# Technical Service Bulletin

SUBJECT:		No: <b>TSB-25-51-002</b>	
<b>LIFTING AROUND THE FRONT END ROOF MOLDING</b>		DATE: <b>April 2025</b>	
		MODEL: <b>Outlander and Outlander Plug-in Hybrid</b>	
<b>CIRCULATE TO:</b>	<input type="checkbox"/> GENERAL MANAGER	<input checked="" type="checkbox"/> PARTS MANAGER	<input checked="" type="checkbox"/> TECHNICIAN
<input checked="" type="checkbox"/> SERVICE ADVISOR	<input checked="" type="checkbox"/> SERVICE MANAGER	<input checked="" type="checkbox"/> WARRANTY PROCESSOR	<input checked="" type="checkbox"/> SALES MANAGER

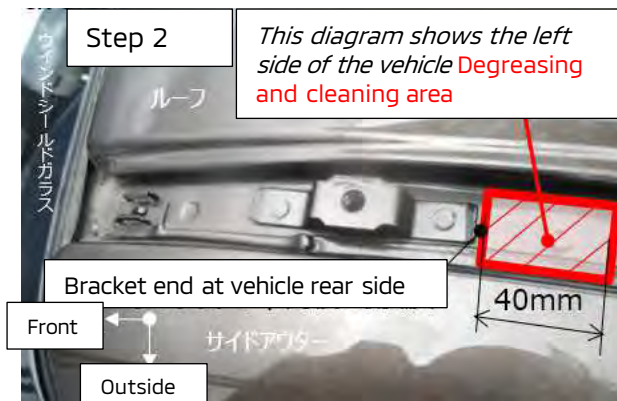
Due to the properties of the material used, roof side moldings expand in high-temperature environments. However, the roof structure may not accommodate this expansion completely, causing lifting in unsupported areas. Therefore, clips have been added to the areas of the roof side molding where lifting may occur.

On a customer complaint basis, please follow the work procedure below and reference the Service Manual as needed to replace the existing roof molding with a new molding and clips.

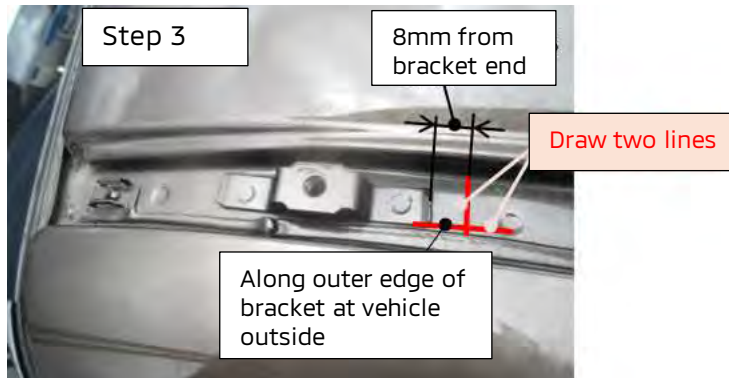
3. Draw lines with a thin marker to mark where to attach the clip.

**Note:** Do not mark with a scribe as this may damage the sheet metal surface.

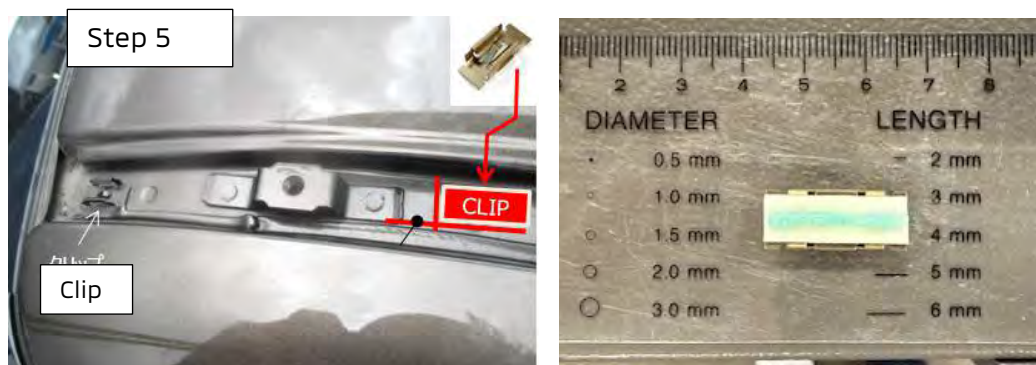
4. Apply the specified adhesive to the clip (MU001595 CLIP, ROOF MLDG).  
Adhesive: Sumitomo 3M DP-8010 or DP-8005 or equivalent

5. Glue the clip along the lines drawn in step 3.

**Note:** Only approximately 1.5 mm of adhesive is necessary.
